# Access Compliance Report

## Public Rights-of-Way

Intersection ID: 46032	Main Street: DOMINION_VILLAGE_DR	Cross Street: MILLSTREAM_RIDGE_DR	Location: S
ADA ID: 38D903104F7B	Ramp Type: PerpDiag	Initial Pass/Fail: Pass	Overall Compliance: No
Codes/Mitigation Info/Possible Solution		Field Measurements/Component Compliance	
Severity Score: 15.25

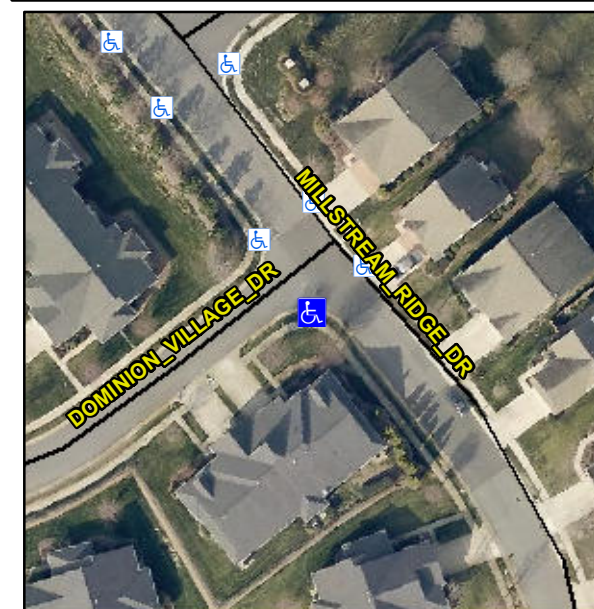
**Not Found, R304.5.3, R304.2.2-Perp, R304.3.2-Para, R305.2, R302.7.2**

Compliance	Description	Data	Compliance	Description	Data
N/A	Ramp Length (in)	49.0	Yes	Ramp Slope (%)	7.2
Yes	Ramp Width (in)	48.0	No	Ramp XSlope (%)	3.5
N/A	Flare Type LT	Sloped	N/A	Flare Type RT	N/A
N/A	Flare Slope LT (%)	0.6	Yes	Flare Slope RT (%)	6.4
N/A	Flare Traversable LT?	Yes	N/A	Flare Traversable RT?	Yes
Yes	Landing Length (in)	48.0	Yes	DWS Provided?	Yes
Yes	Landing Width (in)	48.0	Yes	DWS Contrast?	Yes
No	Landing Slope (%)	4.3	Yes	DWS Length (in)	24.0
No	Landing X Slope (%)	4.9	Yes	DWS Full Width?	Yes
N/A	Landing Curb? (Y/N)	No	No	DWS Offset (in)	2.4
N/A	Shared Landing?	No			
Yes	Gutter Ponding?	No	Yes	Gutter Slope (%)	2.2
No	Gutter Lip Ht (in)	1.0	No	Gutter X Slope (%)	4.1
N/A	Painted X Walk1?	No	N/A	Painted X Walk2?	No
	X Walk 1 Direction	To NW		X Walk 2 Direction	To NE
N/A	X Walk 1 Width (in)	N/A	N/A	X Walk 2 Width (in)	N/A
	X Walk 1 Slope (%)	3.7		X Walk 2 Slope (%)	6.4
	X Walk 1 X Slope (%)	8.2		X Walk 2 X Slope (%)	4.2

**Remove & Replace Curb Ramp With Two New Directional Ramps or Equivalent. Remove & Replace Gutter.**
